Addendum: 1

Date: 4/4/2025

Project: **SACS 2025 Maintenance
 Air Handler Replacement**

Comm #: 24689

*FIRST FLOOR
MECHANICAL PLAN
- UNIT "B"*

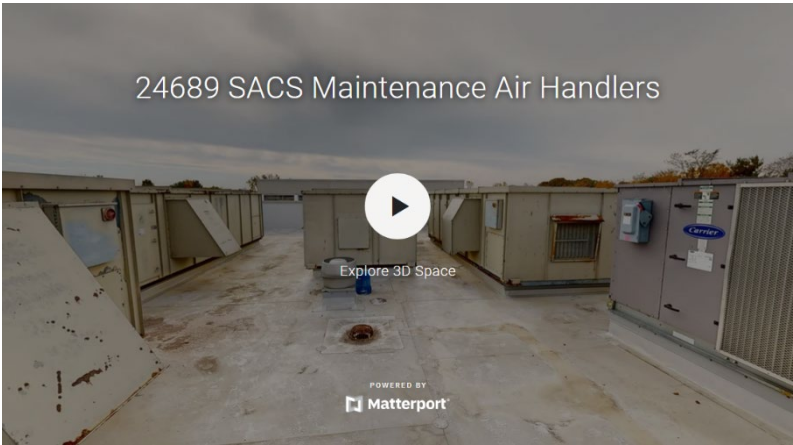
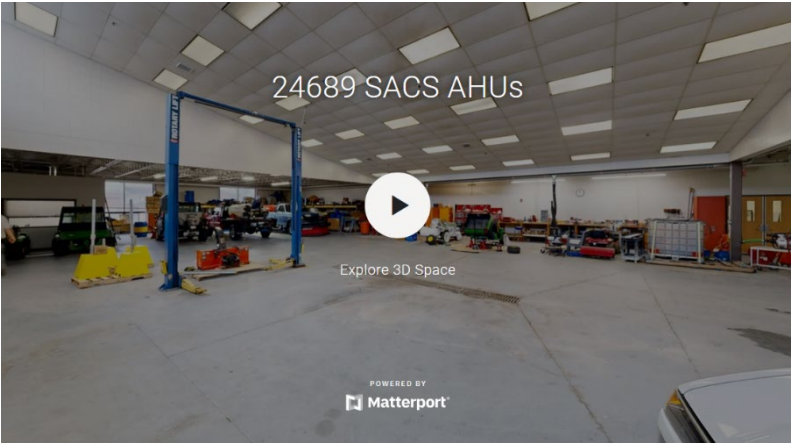
- A.** Revised plan note #1. All aluminum is not required. Refer to supplemental drawing for more information.

1. ALL FABRIC DUCTWORK HARDWARE AND HANGERS SHALL BE GALVANIZED.
2. PROVIDE 1/2" MIN. FABRIC DUCTWORK THICKNESS, ABOUT 1/2" TO 3/4" OF STRUCTURE. COLOR SHALL BE SELECTED BY OWNER. REFER TO FABRIC DUCT SCHEDULE ON SHEET MS01 AND MANUFACTURER'S INSTALLATION REQUIREMENTS FOR MORE INFORMATION.
